Title: Advisory Committee on Reactor Safeguards
Regulatory Policies and Practices
Subcommittee

Date: Tuesday, November 16, 2004

7 As I just said, the purpose of the meeting
8 is to review the staff's draft proposed NUREG report
9 but to mention the expert opinion elicitation of large
10 break loss of coolant accident frequencies. This draft
11 NUREG report is to provide the technical basis for
12 determining an appropriate break size.

Piping Base Case Development

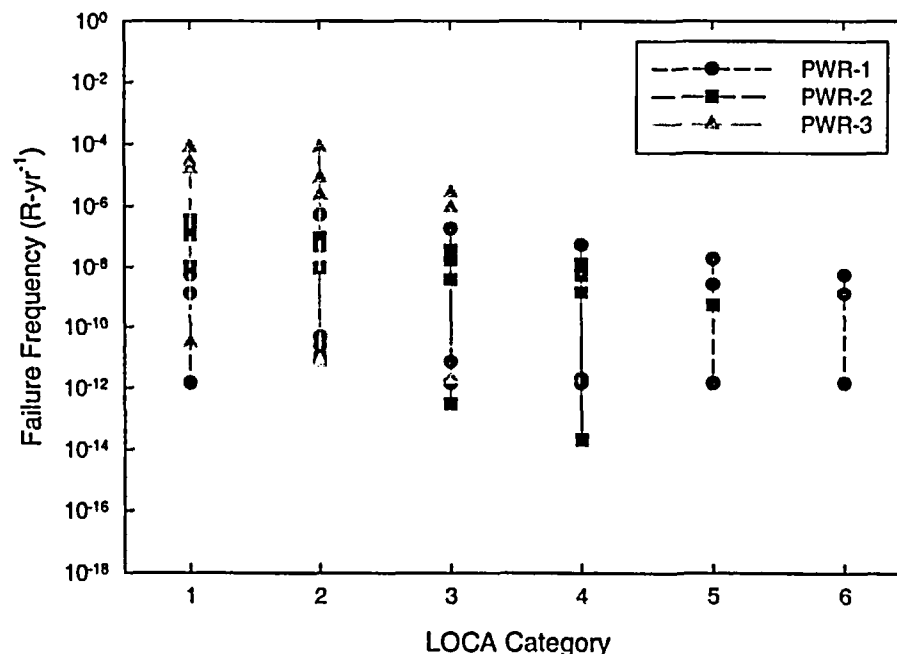
12 MR. BONACA: That figure that a little bit
13 to that figure that we skipped on page 11 where we
14 have the piping base case --

14 MR. BONACA: The question was, you know,
15 we are presented on page 11 with the packing base case
16 so many results.

18 MR. BONACA: A huge spread. And then we
19 move onto this results. And I show the ones at the
20 next page and they're much more converged. Could you
21 tell me how we managed to do that?
